SUBARU

SERVICE BULLETIN

NUMBER: 12-79-03

SUBJECT: Front Door Panel Weather Strip

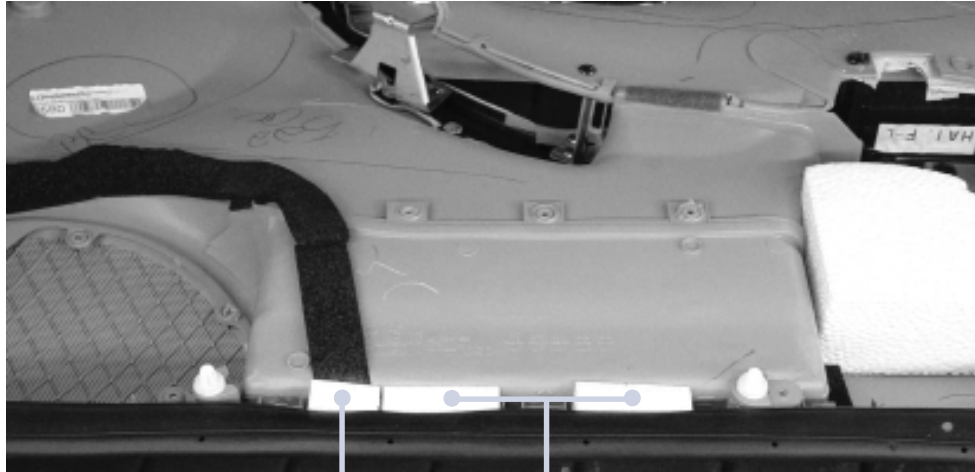
- 1) Remove the door trim panel assembly.
- 2) Remove the four clips at the bottom of the inner door panel and replace with new ones.
